**SUBJECT:** COMANCHE PEAK NUCLEAR POWER PLANT, UNITS 3 AND 4  
DOCKET NUMBERS 52-034 AND 52-035  
RESPONSE TO REQUEST FOR ADDITIONAL INFORMATION NO. 4619 AND 4638

Attachments: 1. Response to Request for Additional Information No. 4619 (CP RAI #165)  
2. Response to Request for Additional Information No. 4638 (CP RAI #166)

### **Response to Request for Additional Information No. 4619 (CP RAI #165)**

**RAI NO.: 4619 (CP RAI #165)**

Figure 18.--All-season PMP (in.) for 6 hr 10 mi<sup>2</sup> (26 km<sup>2</sup>).

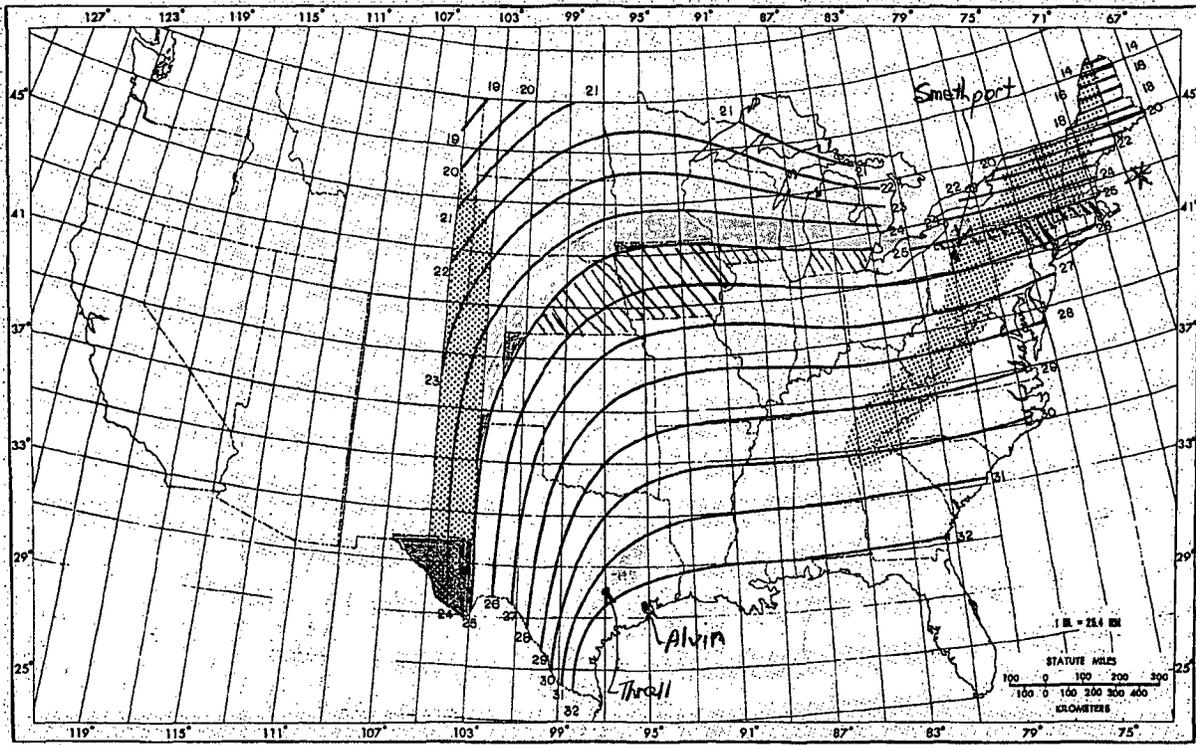
- (a) It is stated that the maximum flood elevation at CPNPP Units 3 and 4 is 793.46 ft msl and this elevation provides more than 28 feet of freeboard under the worst potential flood considerations. It is further stated that the maximum flood elevation is the sum of the maximum flood level that results from a probable maximum precipitation (PMP) on the Squaw Creek watershed (788.9 ft) and the maximum coincident wind waves (4.56 ft). These statements do not provide any indication regarding the magnitude of the frequency of the calculated maximum flood elevation or any information about the assumptions used in the calculation (e.g., it is not clear why the PMP is associated with "the worst potential flood considerations"). Qualitative or quantitative arguments are needed, in conjunction with the evaluation of plant design bases, to show that external flooding is indeed an insignificant contributor to the total CDF (i.e., the frequency of a flooding event that would reach the safety-related plant elevation is less than  $10^{-7}$  per year or its contribution to CDF is a small fraction of the total CDF from all initiating events).

- (b) Please clarify the description of probable maximum flood (PMF) in Table 19.1-205 of Revision 1 of the CPNPP Units 3 and 4 COL FSAR. It is stated that the PMF and maximum coincident wind wave activity results in a flood elevation of 809.28 ft msl and the top elevation of the retaining wall is 805 ft msl. What is the location of the flood elevation of 809.28 ft msl and that of the retaining wall? Qualitative or quantitative arguments are needed, in conjunction with the evaluation of plant design bases, to show that the probable maximum flood is indeed an insignificant contributor to the total CDF from all initiating events.

The three locations for the rainfall events considered in the estimation of PMF frequency (Smethport, PA, Thrall, TX and Alvin, TX) are superimposed on Figure 18 from Reference 4 (below). This figure includes isopleths for various PMPs. The isopleth for 25-inch rainfall passes near Smethport and includes both Thrall and Alvin. The area enclosed by this 25-inch contour is the area of the U.S. that could experience extreme rainfall events equal to or greater than the three events identified above.

Figure 18 shows that there are many states that are completely included in the PMP area. Note that there are two bands of shading from the original map, a north-south band on the west of the PMP region, and a southwest-northeast band along the Appalachian Mountains that indicate areas not included in the PMP calculations. Portions of states that are not totally enclosed in the PMP area are indicated with dark shading. The cross-hatched areas are part of the PMP area but are not included in the calculation of total PMP area to compensate for the two areas (shaded and dark shaded) discussed above. It can be seen that the shaded and

Therefore, the frequency of a PMP of 25 inches over 10 square miles is estimated to be  $1.4 \times 10^{-7}$  per year. This is a conservative estimate of the frequency of the PMP that results in a PMF for CNNPP Units 3 and 4 because additional periods of significant rainfall must also occur in close temporal proximity to the 25-inch 6-hour rainfall event. Given the calculated PMF is not projected to reach the safety-related elevation of the plant and the estimated PMP and PMF frequency of  $1.4 \times 10^{-7}$ /year, the frequency of a flooding event that would reach the safety-related elevation of the plant is projected to be well below  $10^{-7}$  per year.
